Item ID: D2580-1 Accept ***N900040100*** Setup Start ***NS1***
 Revision ID: Stop ***NS2***
 Item Name: 205 Skidtube bent detail
 Start Date: 06/02/2012 Start Qty: 2.00 ***2*** Cust Item ID:
 Required Date: 08/02/2012 Req'd Qty: 2.00 ***2*** Customer:
 Reference:

DRAWING NO. D2580	TITLE 205 SKIDTUBE ASSEMBLY	REV. E	DART AEROSPACE LTD ENGINEERING ORDER	D.E.O. NO. D2580-E-1	SHEET NO. SHEET 1 OF 1	SCALE NTS
DRAWN <i>UP</i>	CHECKED <i>ASS</i>	MFG. APPR. <i>EC</i>	APPROVED <i>[Signature]</i>	DE APPR. <i>[Signature]</i>		
DATE 11.12.13	DATE 11.12.13	DATE 11.12.13	DATE 11.12.13	DATE 11.12.13

CHANGE ALL C'BORED WELDED CROSSBOLT SPACERS TO SWAGED SPACERS

SECTION B-B, F-F, I-I
NOT TO SCALE

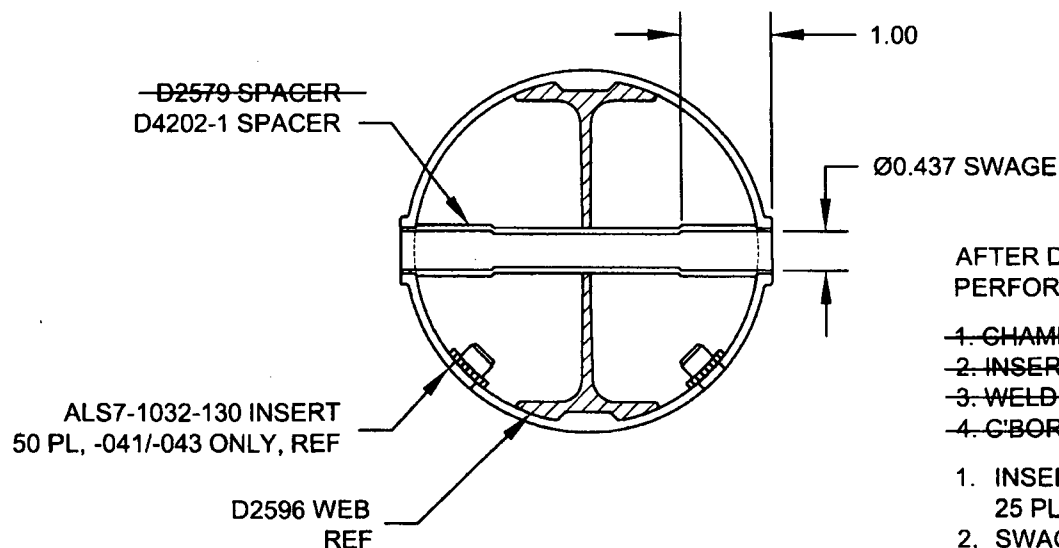
SECTION B-B, SECTION F-F, & SECTION I-I ARE AMENDED AS FOLLOWS
FOR ALL HOLES THAT WERE ORIGINALLY C'BORED:

1. CHAMFER HOLE 0.050 X 45°
2. INSERT D2579 SPACER (20 PLACES)
3. WELD INTO PLACE AND GRIND FLUSH
4. C'BORE D2579 SPACER TO Ø0.437 X 1.00 DEEP

*** FOR -045 SKIDTUBE ONLY:**
WELD 4X D2579 SPACERS PER DWG
IN LOCATIONS MARKED "NO C'BORE".
REF SHEET 4 OF DWG.

1. INSERT D4202-1 SPACER, 20 PL (-041) OR 20 PL (-045) OR 25 PL (-047)
2. SWAGE TO Ø0.437 X 1.00 DEEP PER QSI 002
3. TRIM / GRIND FLUSH PER QSI 002
